Re: Renewal of Planning Approval for Temporary Private Swimming Pool for a Period of 3 Years in "Village Type Development" zone, Lot 2158RP in DD104, Ngan Tam Mei, Yuen Long.

Submit Supplemental Information for s.16 application

Sketch No.1 (21/02/2025)

Sketch No.2 (21/02/2025)

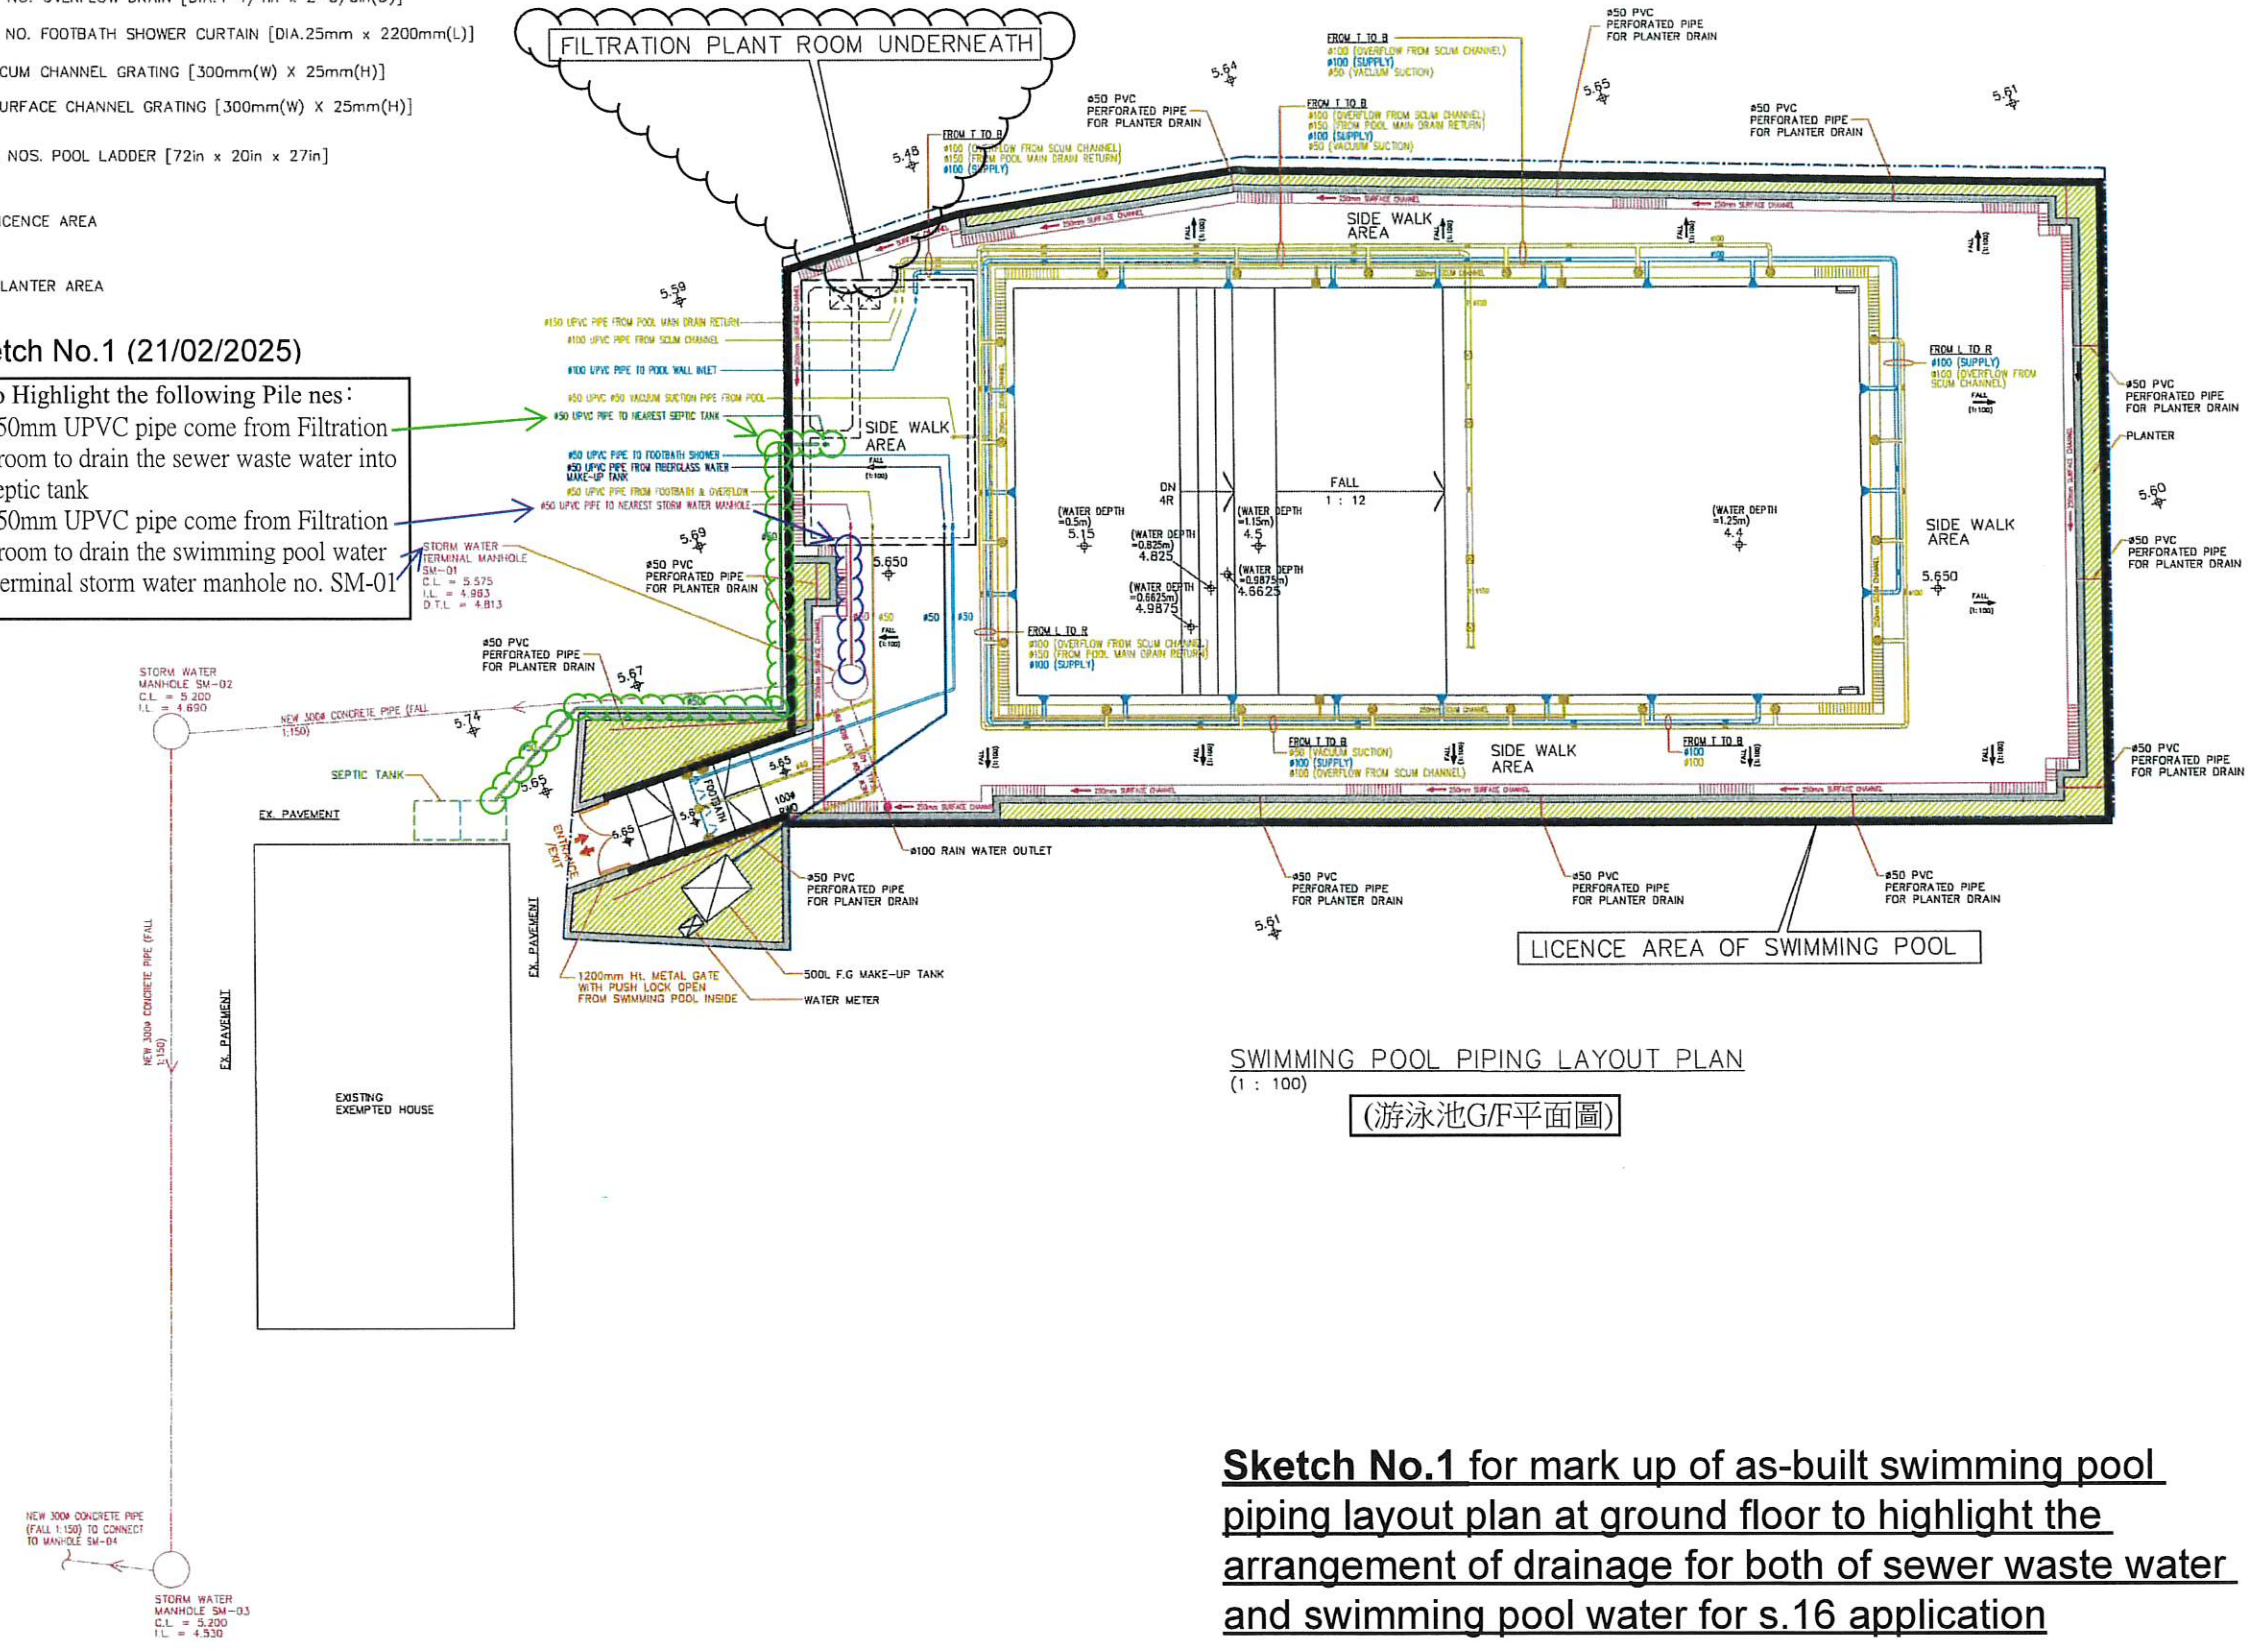
Markup Sketch to Highlight the following Pipe nes:

- 1) Dia. 50mm UPVC pipe come from Filtration plantroom to drain the sewer waste water into the septic tank
- 2) Dia. 50mm UPVC pipe come from Filtration plantroom to drain the swimming pool water into terminal storm water manhole no. SM-01

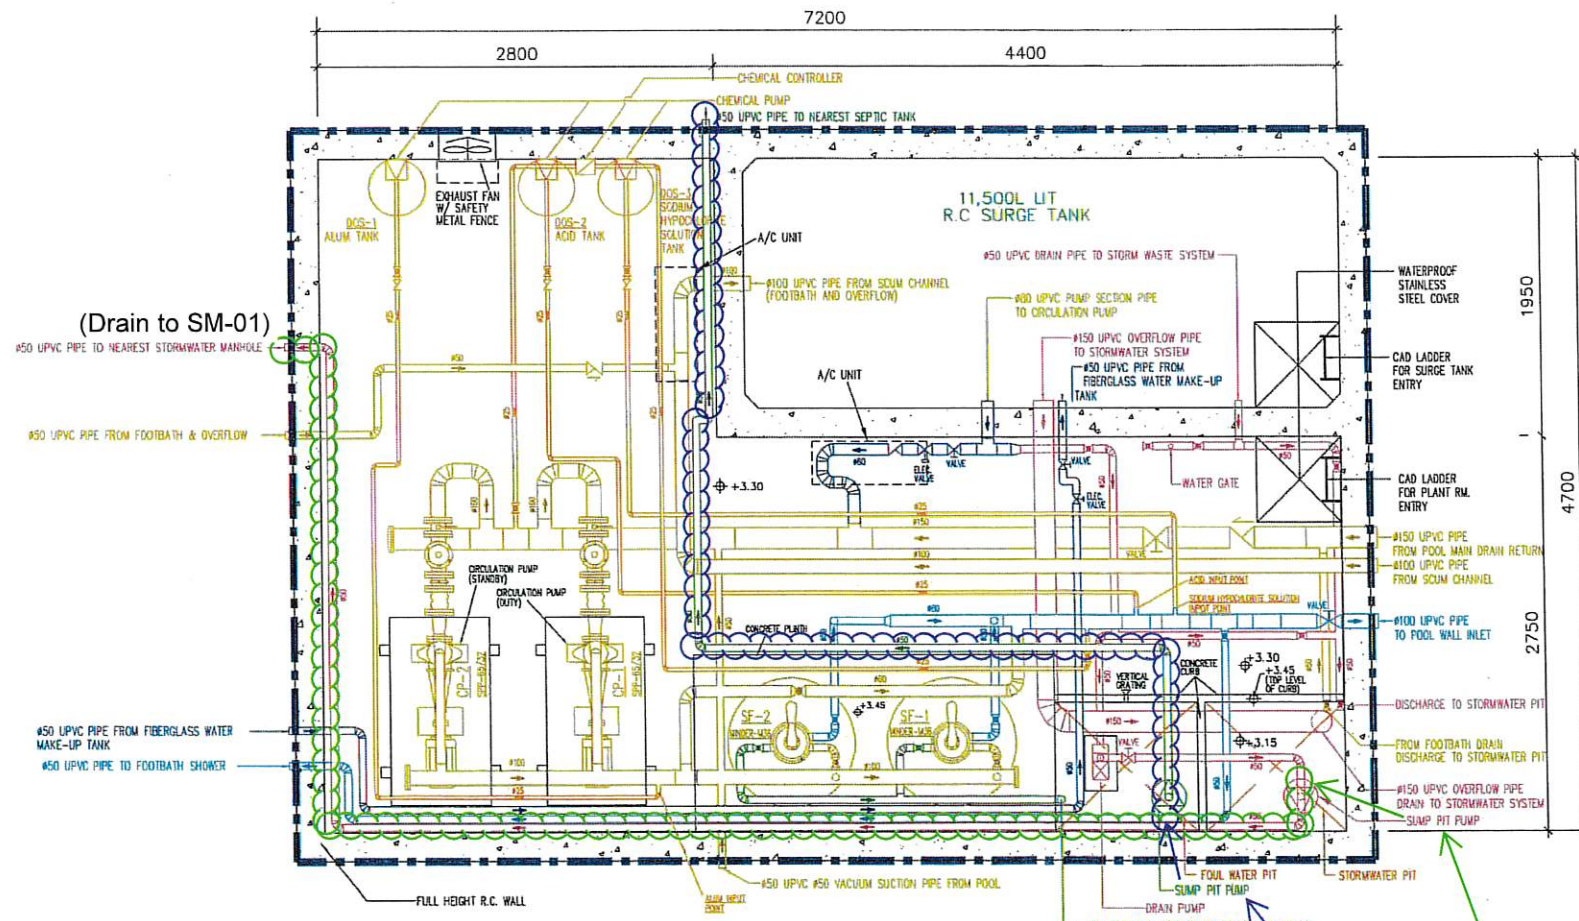
- Markup Sketch to Highlight the following Pipe Lines:
- 1)  Sump pit pump connected with dia.50mm UPVC pipe to drain the sewer waste water to the nearest septic tank as shown on Swimming Pool Piping Layout Plan (Ground Floor)
 - 2)  Sump pit pump connected with dia.50mm UPVC pipe to drain the storm water to storm water manhole no. SM-01 on swimming pool ground floor.
